FINAL PLAT

COTTAGE GARDENS

Re: S/D 90-64 (Final Plat) Cottage Gardens Addition

CASE NUMBER: S/D 90-64 - COTTAGE GARDENS ADDITION

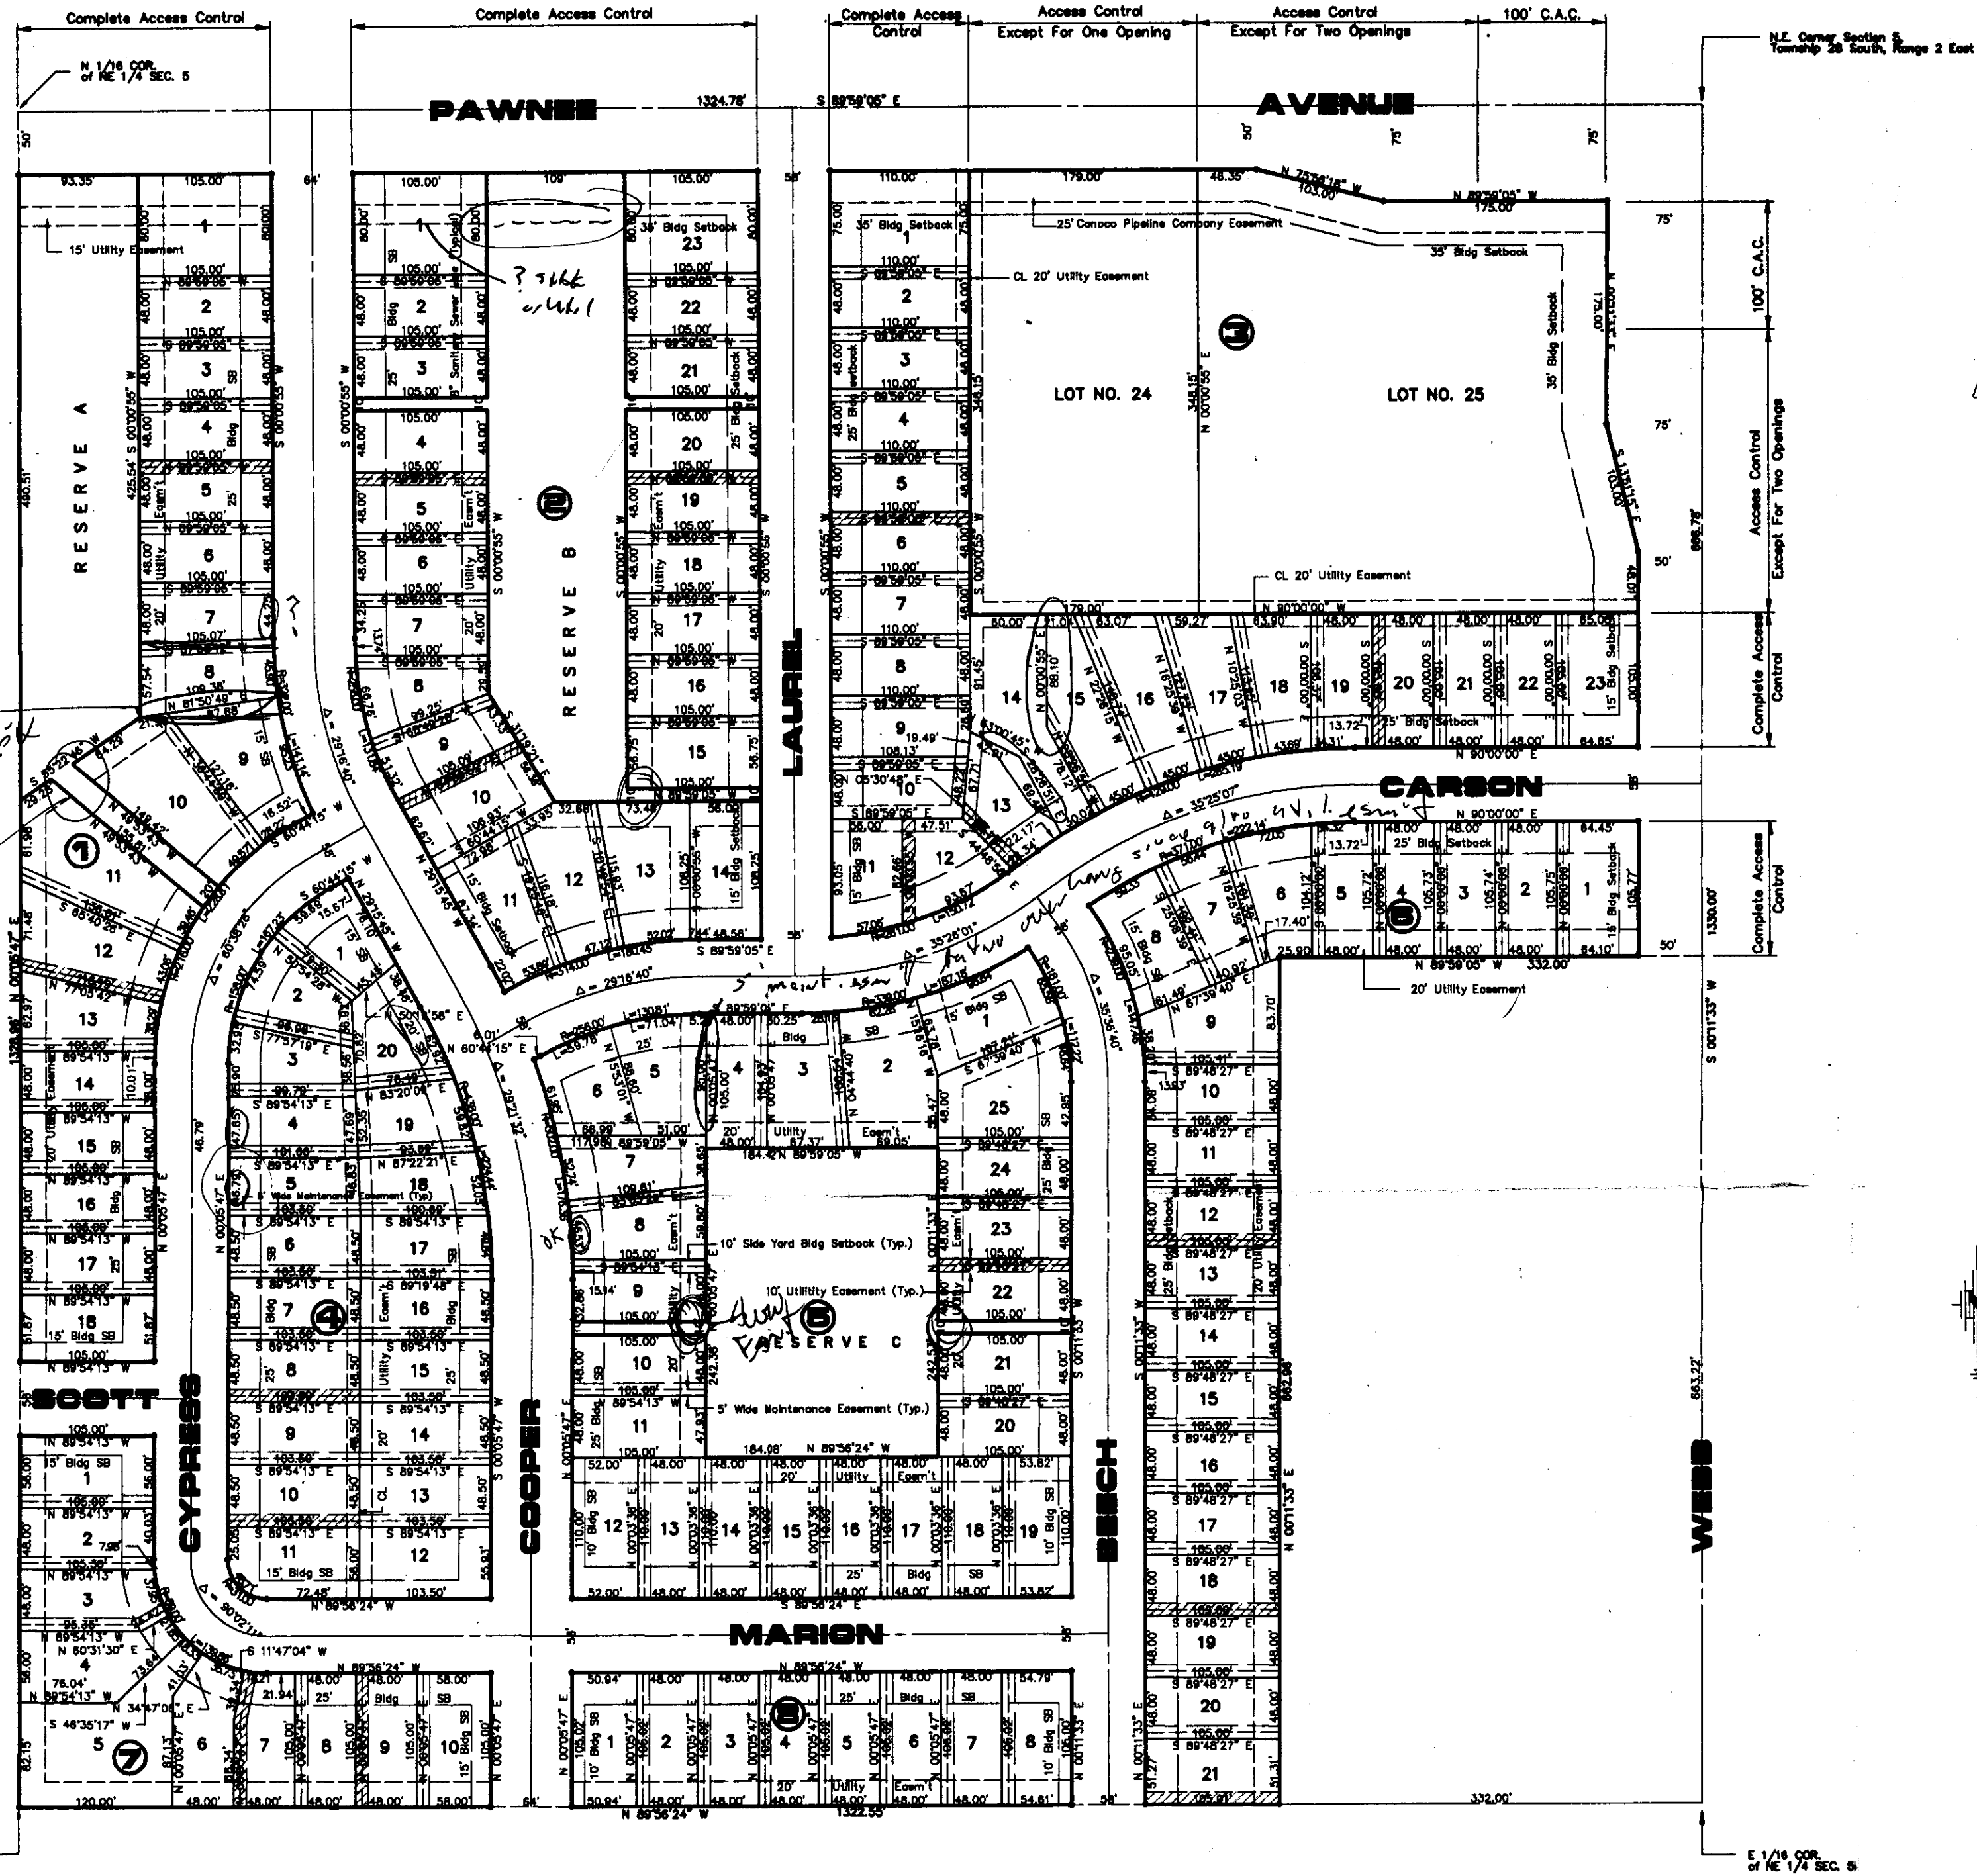
- Z. The utility easement and/or setback along the north line of the residential lots and Reserve B adjacent to Pawnee shall be clearly labeled with the dimension of the setback (35-feet), or of an easement. It shall be clearly indicated as such. In particular if an easement is to cross Reserve B, and shall be shown along the north end of this Reserve and Lots 1 and 23 either side of the Reserve.

- M. The final plat shall indicate the recording information for the Conoco pipeline easement on this property.
- N. On the final plat, the center lines (CL) of Webb and Pawnee shall be labeled.

- O. Because of the use of 10-foot sideyard setbacks required for zero lot line development, certain corner lots will be very limited in the buildable area available when a typical 15-foot sideyard setback is also required. It is recommended therefore that a 10-foot sideyard be allowed for a corner lot in cases where the building area would be less than the typical 38 foot areas of the majority of the lots. For example, Lot 8, Block 8 and Lot 19, Block 2 would only have a 30-foot width for building.

- P. The present print on the final plat, particularly the dimensions, bearings, size of easements and setbacks, etc. on the face of the plat, are too small for microfilming and are of a size not accepted by the Register of deeds for recording a document. The

final plat tracing shall therefore use a larger print and preferably a more appropriate scale. The detail of this plat may require the tracing to be done on at least 2 sheets.

- Q. Except when located on a corner, lot frontages at street right-of-way should meet the minimum standard. For this cluster development a 48-foot frontage should be maintained unless physical constraints can be identified. In particular, Lot 7, Block 1 and Lots 4 and 5, Block 4 should be able to conform to the 48-foot minimum frontage by the shifting of lot lines of adjacent lots.

- R. On Lot 15, Block 3, the maintenance easement and zero foot sideyard setback should be continued along this lot's west line in order to allow Lot 14 to use the zero lot line option in the buildable area of this lot. If lot 13 of this Block is also intended to be used for a zero lot line home, a maintenance easement and sideyard setback should be shown along the southwest line of Lot 14.

- S. For Lot 4, Block 5 a zero lot line could be allowed if a 5-foot maintenance easement is shown along Lot 5, within the utility easement. However, no roof overhang should be allowed where an overlapping utility easement is also present. Consequently, the platting text would need to be amended to indicate that the roof overhang would not be allowed if the 5-foot maintenance easement was also located in a utility easement.

- T. On the final plat tracing, where utilities are crossing the Reserves, such as along the north line of Reserve B, the south line of Reserve A, and the two entrances to Reserve C, utility easements shall also be clearly indicated as crossing these Reserves.

- U. Easements were requested by the Utilities between: Lots 2 and 3, Block 4, Lots 19 and 20, Block 4 and Lots 4 and 5, Block 6. These easements shall be indicated on the final plat tracing.

- V. On the final plat tracing an insert of an enlarged area of lots shall be provided to better indicate the platting of the 5-foot maintenance easement, 10-foot sideyard setback and in certain cases the overlapping utility easements.

- W. On the final plat tracing the word "Acting" shall be deleted from the MAPC signature block.
- X. The applicant is advised that the buildability of Lot 10, Block 3 is questionable. A 10-foot easement and a 10-foot sideyard setback will leave a buildable width of 28-feet for this lot.

- Y. Unless a maintenance easement and sideyard setback are platted on Lot 5, Block 7, this Lot could only be developed for a conventional or non-zero lot line home
